# **PRODUCT ADVISORY**

## **Data Sheet Specification Change for Intersil Products ISL8200MMREP and ISL8200MMREP-T**

**Refer to:  
PA13028**

**Date: March 15, 2013**

# Old Reflow Profile – PA13028

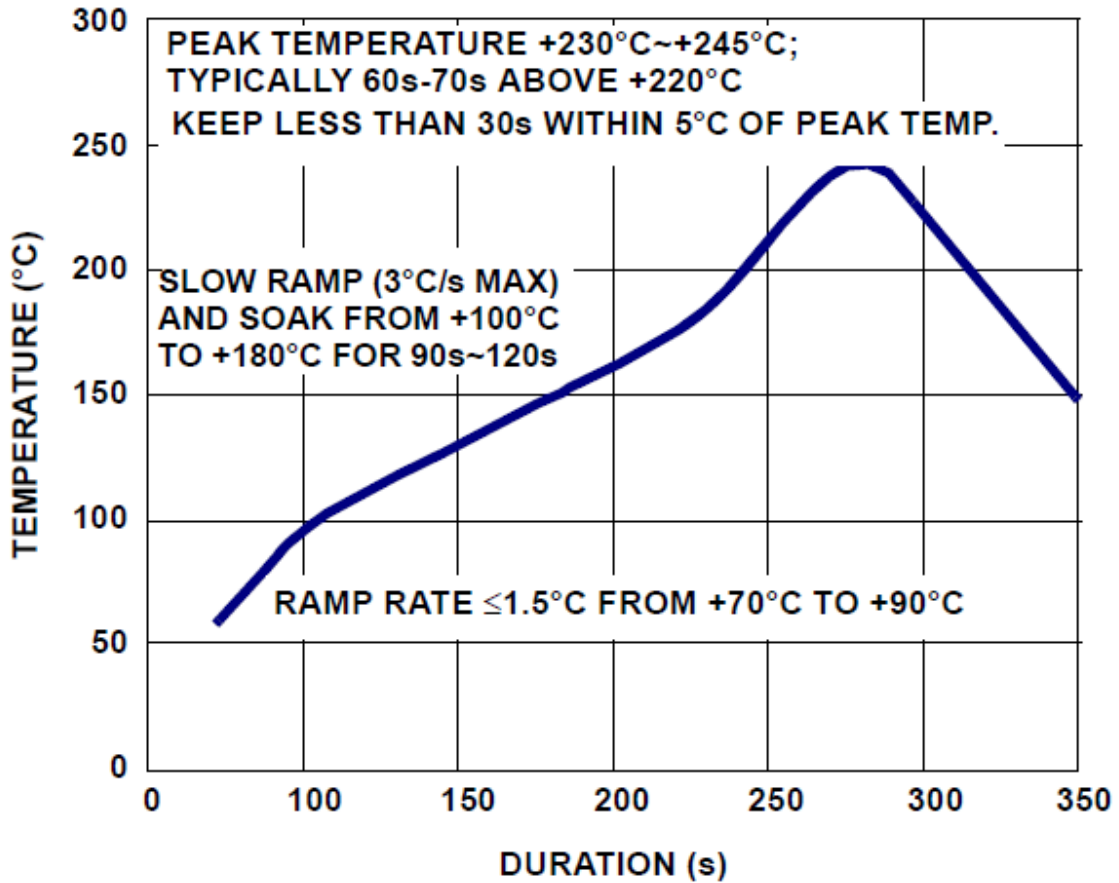
This advisory is to inform you that Intersil has updated the data sheet specification for the ISL8200MMREP and ISL8200MMREP-T products. The update includes changes to the reflow profile only. The changes include differences in the dwell time at peak temperature; peak temperature and the slow ramp soak duration. The old and new reflow profiles are contained on the following pages. There have been no changes to the electrical specifications table in the data sheet. There have been no changes made to the die/silicon or device itself. There will be no change in external marking of the packaged parts.
